Project	IEEE 802.16 Broadband Wireless Access Working Group < http://ieee802.org/16 >	
Title	Forcing all SSs to be reset at once	
Date Submitted	2005-07-09	
Source(s)	Yeongmoon Son, Jungje Son, Panyuh Joo Samsung Electronics Co. Ltd.	Voice: +82-31-279-5845 FAX: : +82-31-279-5130 ym1004.son@samsung.com
Re:	IEEE P802.16-2004/Cor1/D3	
Abstract	This contribution proposes the scheme for forcing all SSs to be reset at once	
Purpose	Discuss and adopt this contribution	
Notice	This document has been prepared to assist IEEE 802.16. It is offered as a basis for discussion and is not binding on the contributing individual(s) or organization(s). The material in this document is subject to change in form and content after further study. The contributor(s) reserve(s) the right to add, amend or withdraw material contained herein.	
Release	The contributor grants a free, irrevocable license to the IEEE to incorporate material contained in this contribution, and any modifications thereof, in the creation of an IEEE Standards publication; to copyright in the IEEE's name any IEEE Standards publication even though it may include portions of this contribution; and at the IEEE's sole discretion to permit

Figure 1 – The Operation by Restart Count TLV encoding in DCD message

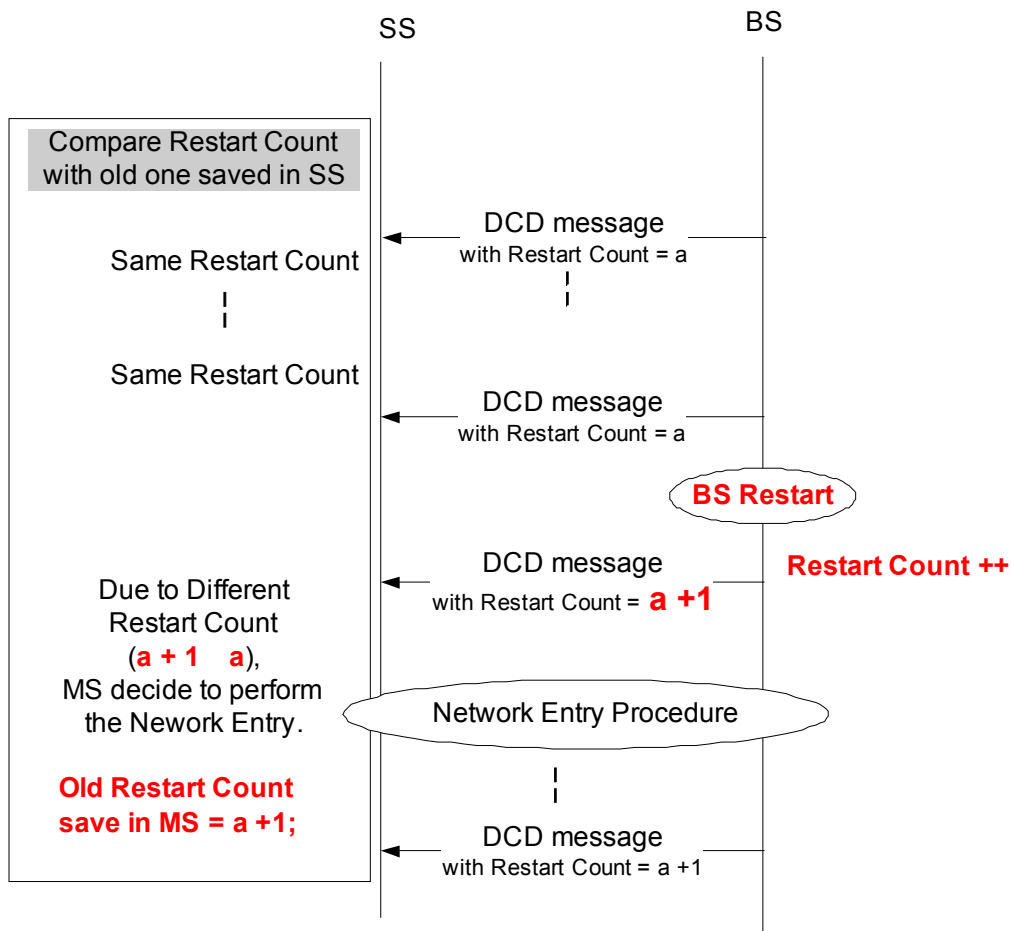
BS may intentionally increment the restart count to be included in DCD message for the purpose of forcing all SSs to perform the Network Entry due to BS's some problem.

Because the restart count is periodically broadcasted, the restart count scheme is available regardless of SS's state (i.e. normal state, sleep, idle mode)

Figure 1 shows the operation by BS Restart Count TLV encoding in DCD message
